# Code Amendment Proposal Application **OSSC 22-03**

Specialty code:	Oregon Structural Specialty Code (OSSC)
Code section(s):	1102.1.2.11

Briefly explain the subject of your proposal:	The proposal adds an exemption for accessible outlets for counters between range and refrigerator if the counter is less than 18" wide.
---	---

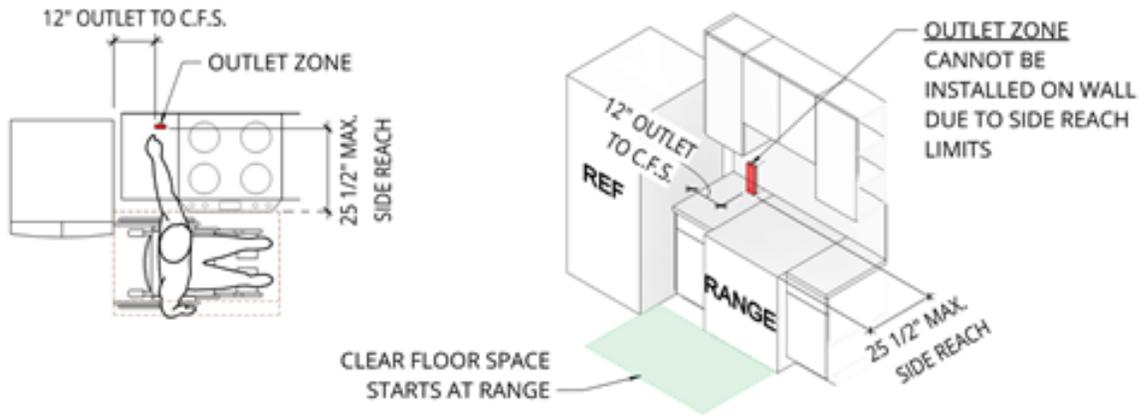
1. As the code currently exists, our experience as architect of many multifamily projects is that often accessible outlets are driving kitchen design, and the result is less accessible kitchens. Either cabinets are reduced to 9" in width, drawers are removed or shortened to fit outlets in the location where drawers are, or certain kitchen layouts are avoided all together (such as kitchens with a corner). Drawers can be some of the most accessible storage in the kitchen, so it would seem less ideal to reduce them either in height or width to accommodate outlets when there are other accessible outlets in the kitchen, which is happening often.

Within residential units, electrical code requires an outlet for any counter that is 12" in width. There are many kitchen configurations that have a refrigerator and range near each other with a cabinet in between, such as a galley kitchen. Almost all refrigerators extend past the counter to ensure the door operates properly (counter depth refrigerators align the refrigerator box with the countertop but then extend 2-3" past the counter for the door). Only the lowest end and highest end ranges are counter-depth, and generally the lower end ranges that are counter depth are rear control ranges. From our projects, our experience is that a large proportion of ranges used in apartments are front control slide in ranges, that are about 28 1/2" deep. Therefore, we are finding that many projects either select a rear control range or are reducing the cabinet between ranges and refrigerator to 9" to avoid the outlet all together. Neither option make the kitchen more accessible. For the first option, a rear control range requires reaching over a burner to reach the controls. For the latter option, making the counter between the range and refrigerator only 9" leaves little space between the refrigerator and range for setting items down when accessing the refrigerator, freezer and range. A wider counter, such as 18", would make the counter usable for users in a wheelchair by providing a wider counter for either loading or unloading the refrigerator as well as space next to cooking. If there is an outlet there, it may be a good space to leave a small appliance plugged in, such as toaster or coffee maker.

The 2017 A117.1 Amendments approved an exemption for the corner (exception 3) when obstructed by appliances with the intent to not have outlets drive kitchen design. This exemption follows the same logic but applies to other kitchen types that do not have a corner, such as linear or galley. Standard kitchen design will not allow for use of exceptions 3 and 4, as either the range or refrigerator are the appliances that extend past the counter.

4. In a kitchen where a clear floor space for a parallel approach cannot be located at a countertop between range and refrigerator, receptacle outlets over the countertop shall not be required to comply with the section provided that the countertop area does not exceed 18 inches (460 mm) in width.
